Coastal Access Modification Report GAL-MR3

Proposed changes to the submitted King Charles III England Coast Path proposals for Gretna to Allonby, Cumbria

Location affected: Longcroft/Whitrigg, Kirkbride

Natural England's Modification Report to the Secretary of State

Map GAL-MR3a Longcroft/Whitrigg, Kirkbride

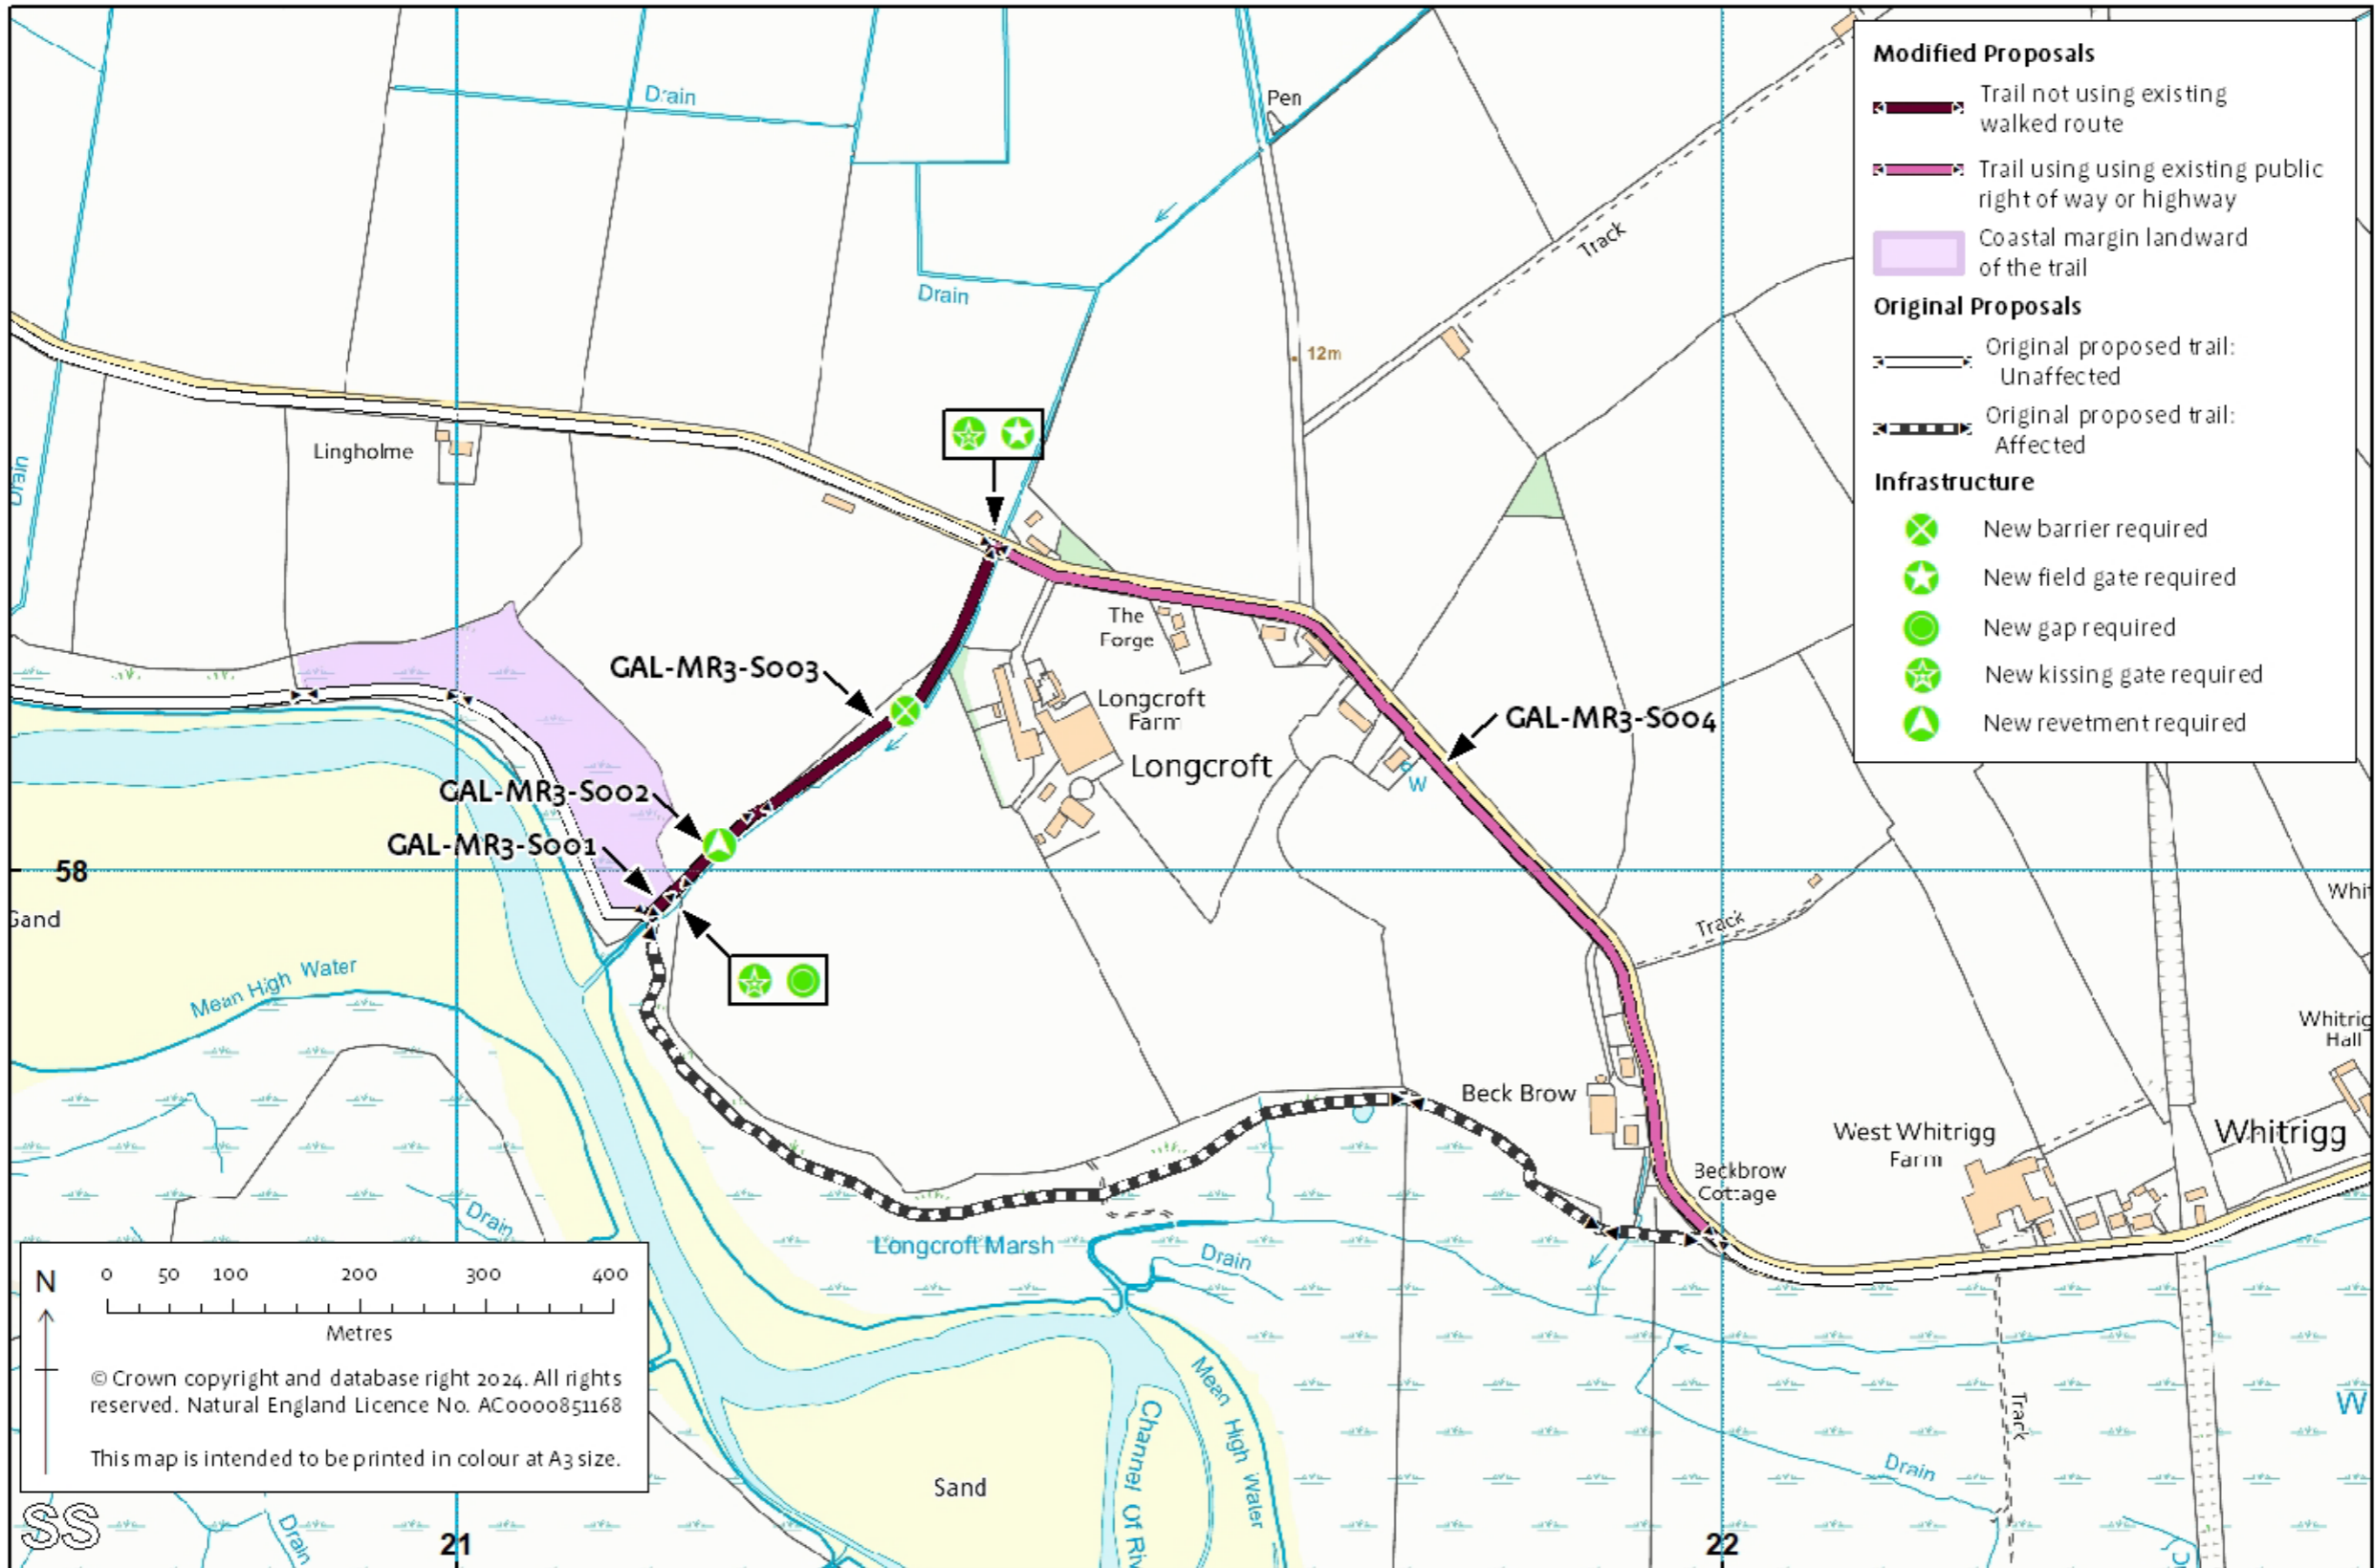
A.2.1 Our proposal (see map GAL-MR3a) is, from west to east, to re-route the path shown as GAL-3-S033 to S036 inclusive, in our original report. The realigned trail would extend for a length of 1.27 kilometres at a maximum of 565 metres northeast of the original route proposed.

A.2.2 From the eastern end of GAL-3-S032, the revised route would head generally north, initially to the landward boundary of the marsh, before continuing through the margin of an adjacent field to the nearby road. Between the marsh and the road, the revised route would follow the western bank of a small stream, being separated from the adjacent field by a new fence. On reaching the road, the revised route would follow the eastern part of the originally proposed optional alternative route, on the road edge or verge, to re-join the previously proposed route at Beckbrow Cottage.

Map GAL-MR3b Longcroft/Whitrigg, Kirkbride - Key Statutory Environmental Designations

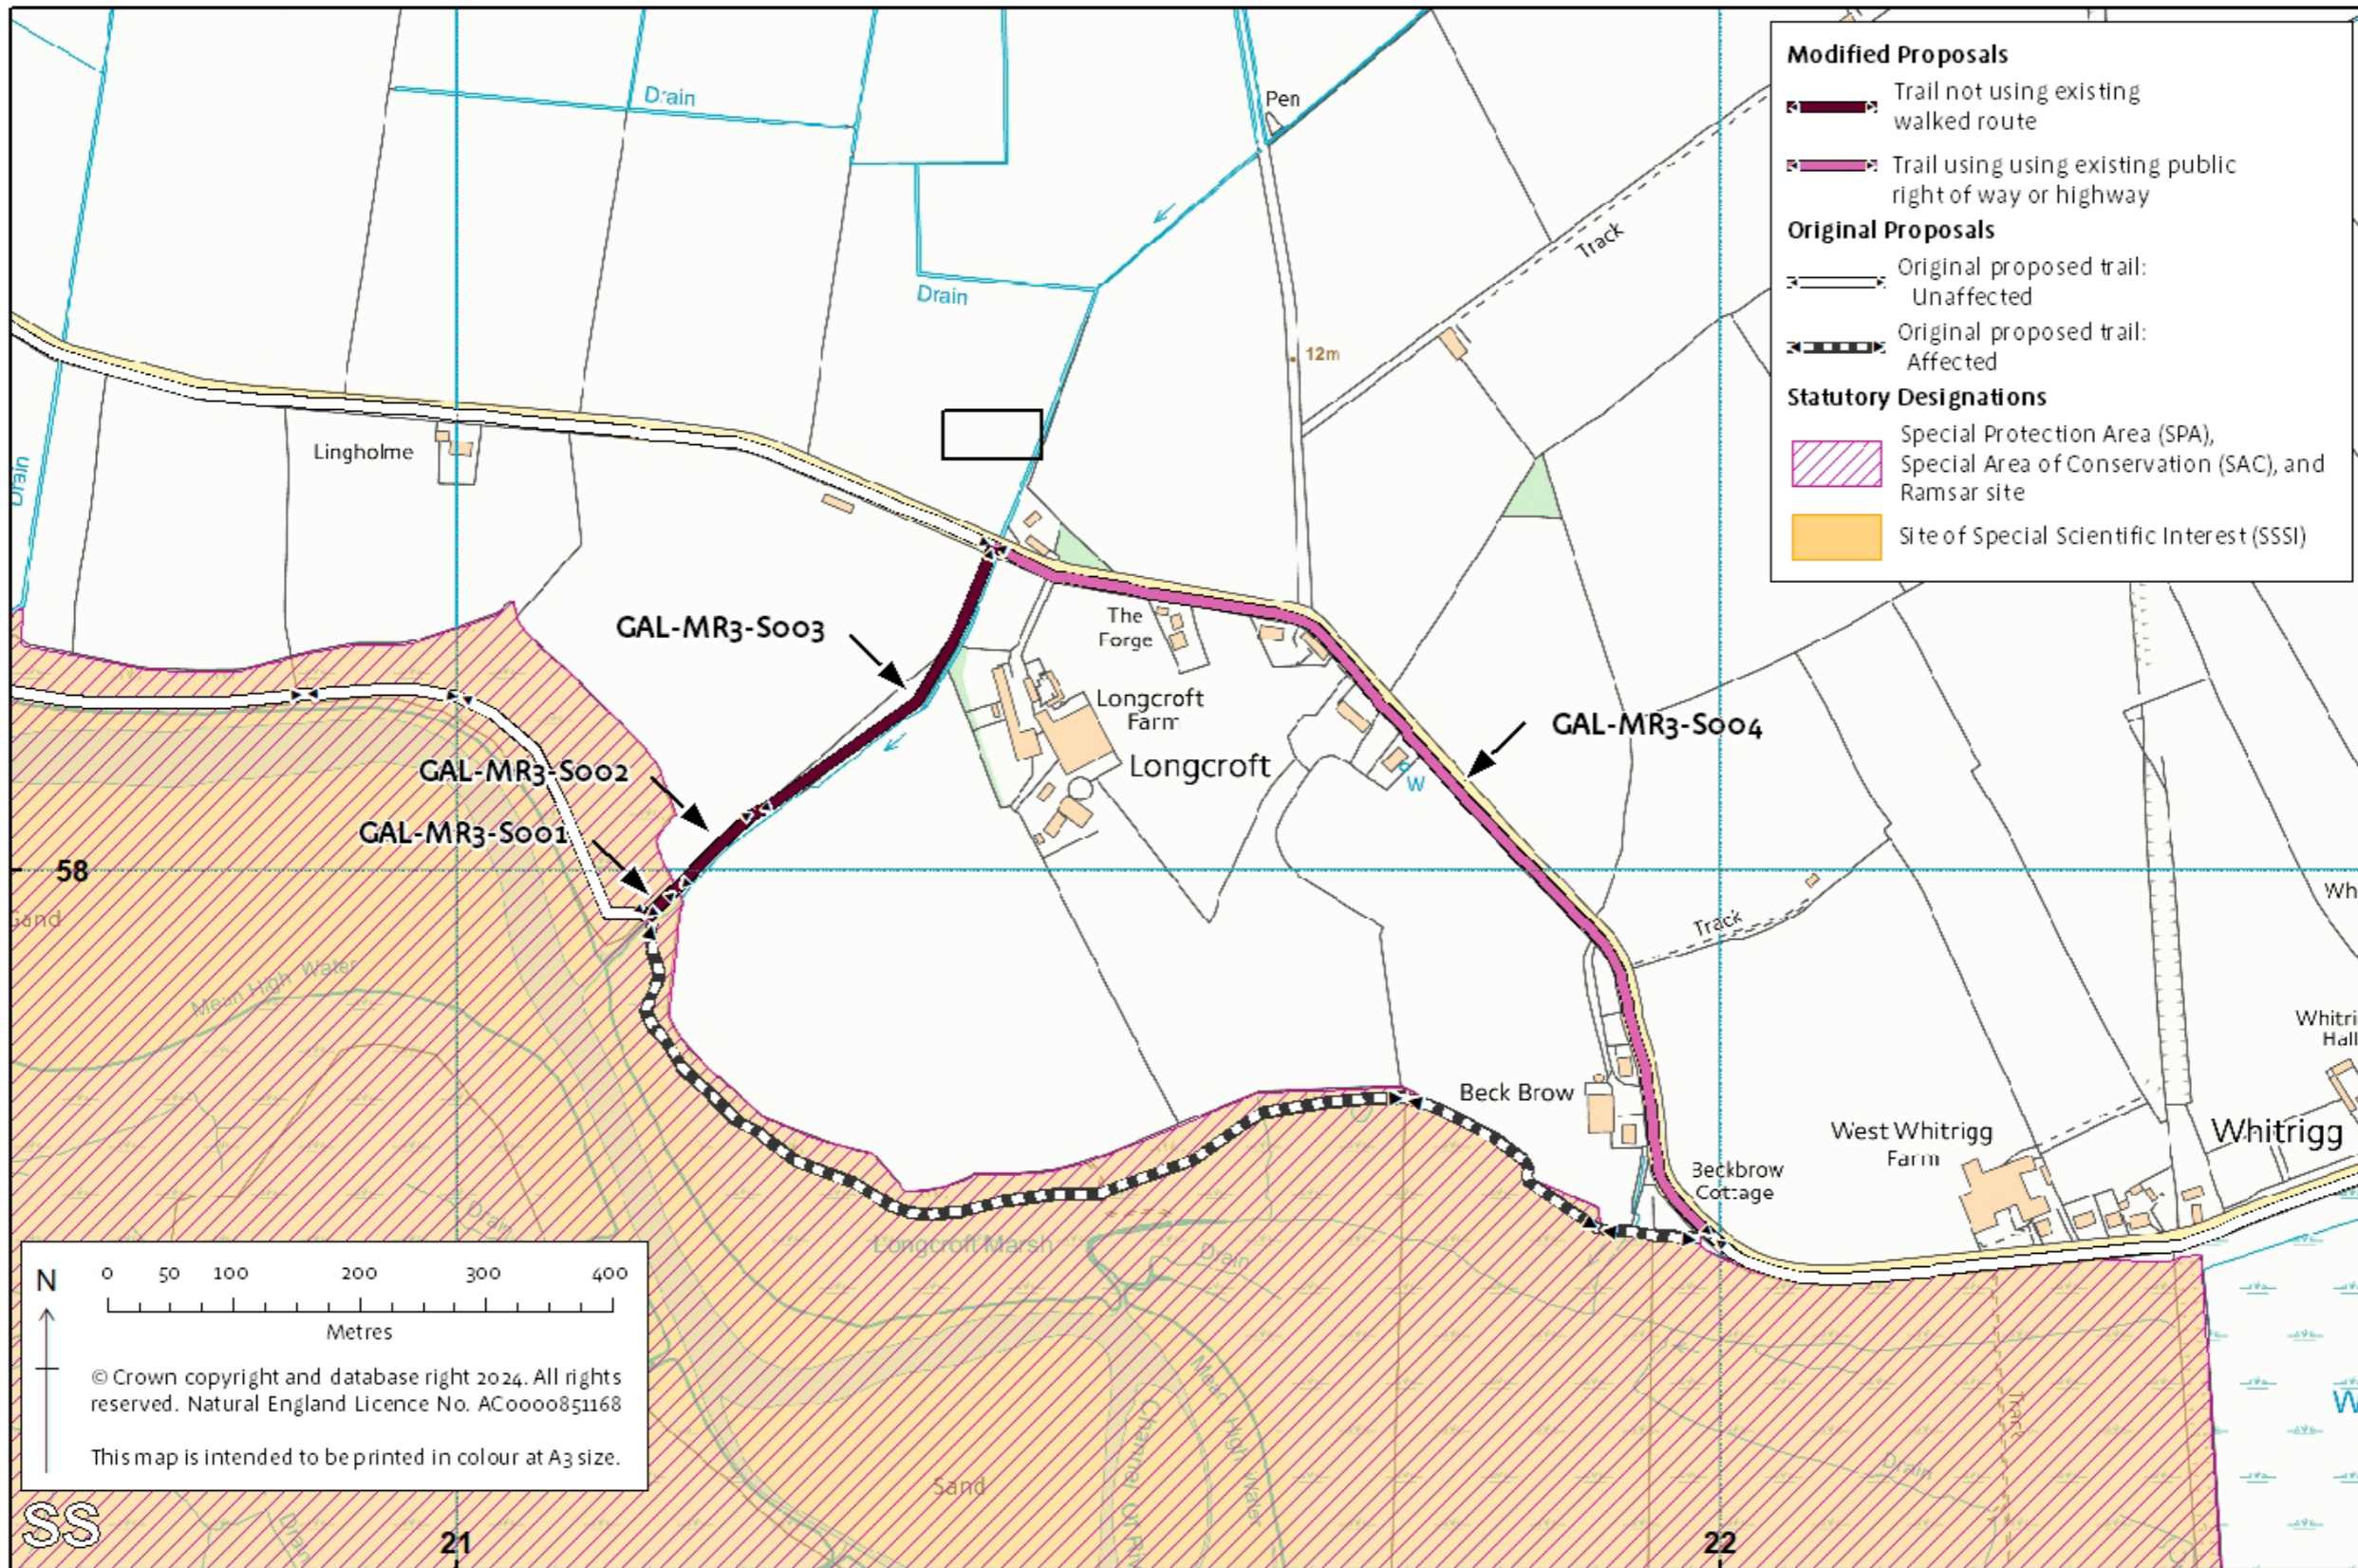
The route subject of the proposed modification is aligned on grazing marsh for approximately 30m within the above designated sites, and then through a field which is adjacent to the designated sites. Areas of saltmarsh and flats will fall within the coastal margin. Access rights to the saltmarsh and flats will be excluded by direction, under s25A of CROW 2000 (as being unsuitable for access).

The proposed modification reduces the length of the trail on saltmarsh by 1 km, compared to the original proposed route. The trail was originally proposed to be aligned along the landward edge of Longcroft Marsh and would now avoid this area. Therefore, the proposed modification reduces the potential for non-breeding and breeding bird disturbance, compared to the originally proposed route.
